<b>Subject:</b>  RATTLE NOISE FROM BOTTOM OF A-PILLAR	<b>Bulletin No:</b> 09-001/14
	<b>Last Issued:</b> 01/08/2014

2014 Mazda3 with VINS lower than JM1BM\*\*\*\*\*154277 (produced before December 1, 2013)

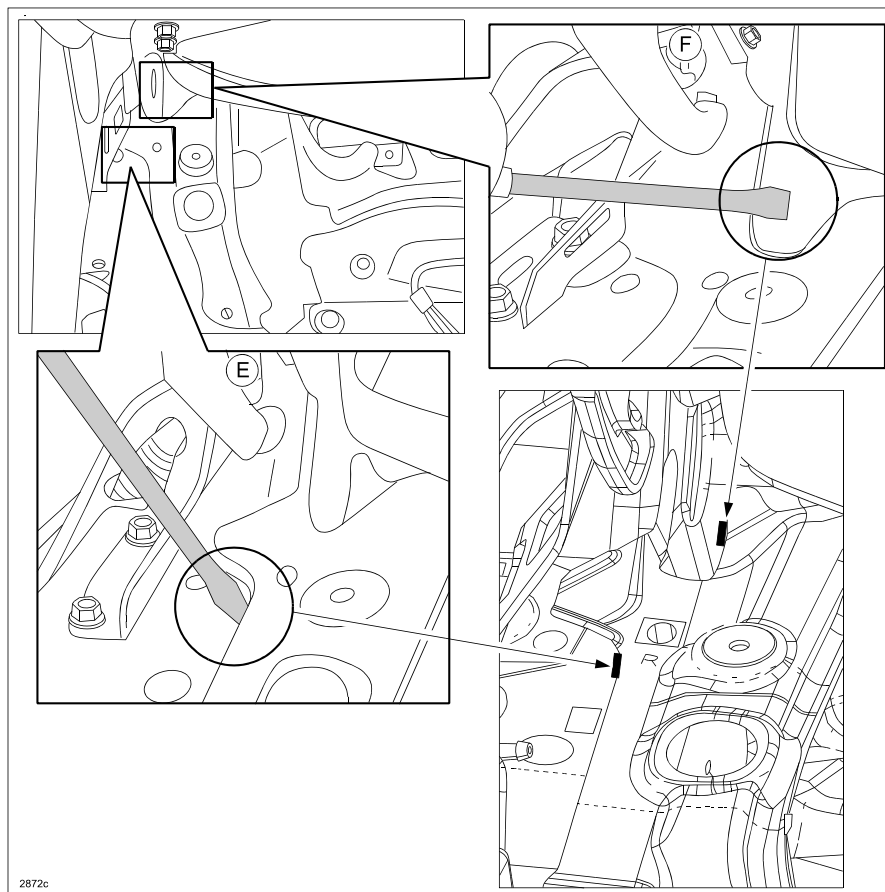
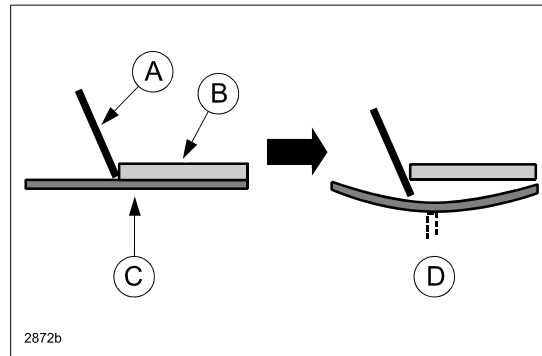
Some vehicles may exhibit a rattle noise from the bottom of the A-pillar when driving on rough roads or over bumps. This is caused by the cowl upper plate and/or dash upper panel interfering with the wiper bracket. To correct the problem, the shape of the wiper bracket has been changed. For the affected vehicles, a clearance needs to be created between the wiper bracket and cowl upper plate and between the wiper bracket and dash upper panel.

- Place the tip of a covered\* flat-blade screwdriver (A) between the two panels (B and C) at the joint (between the wiper bracket and cowl upper plate (E) and between the wiper bracket and dash upper panel (F)) and hit the head of the screwdriver with a hammer to create a clearance of approximately 0.5 mm (D) between the two panels.

**\*NOTE:** To avoid damage to the paint, wrap protective tape around the tip of the screwdriver. If the panels are scratched, apply appropriate corrosion protection primer.
